REPLACING AN IS2000 TELEPHONE WITH A VOICCOM PHONE

Summary	
News Type	Engineering Note
Purpose	To detail the process of replacing an IS2000 Telephone with a VoiceCom Phone.
Product Range	IS2000 Telephones & VoiceCom Phones
Target Audience	Electrical Engineering Managers of Sites with Group I IS2000 Telephone Installations
Date of Issue	6 th July 2015

PARTY LINE CONNECTIONS

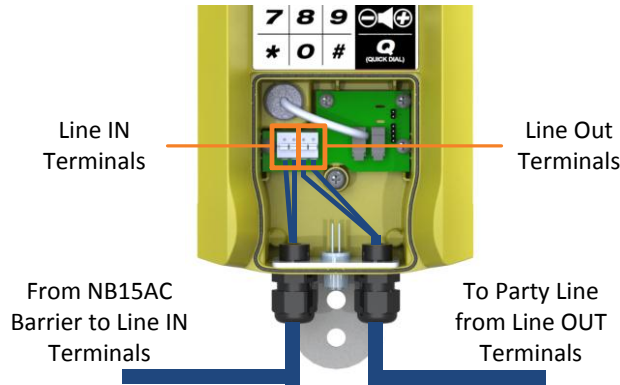
Both the VoiceCom Phone and the IS2000 Telephone allow multiple phones to be connected in parallel in what is called a “Party Line” configuration. The ‘Line OUT’ terminals of these telephones are simply a parallel connection to the ‘Line IN’ terminals. A “Party Line” connection is made by wiring the ‘Line IN’ terminals of a telephone to the ‘Line OUT’ terminals of another telephone. This configuration allows a phone call to be answered in multiple locations.

Although the VoiceCom Phone can be directly installed in place of an IS2000 Telephone, it is important to note that the IS2000 Telephone and the VoiceCom Phone are not compatible when installed in the same party line configuration. That is a **VoiceCom Phone cannot be on a party line with an IS2000 Telephone.**

A maximum of 3 VoiceCom phones should share a party line. Actual performance of these party-line-connected phones will depend on the connecting cable type overall, length of the connecting cables, quality of connections in junction boxes and the number of connected phones.

IS2000 Telephones are not to be connected in the same party line as VoiceCom Phones.
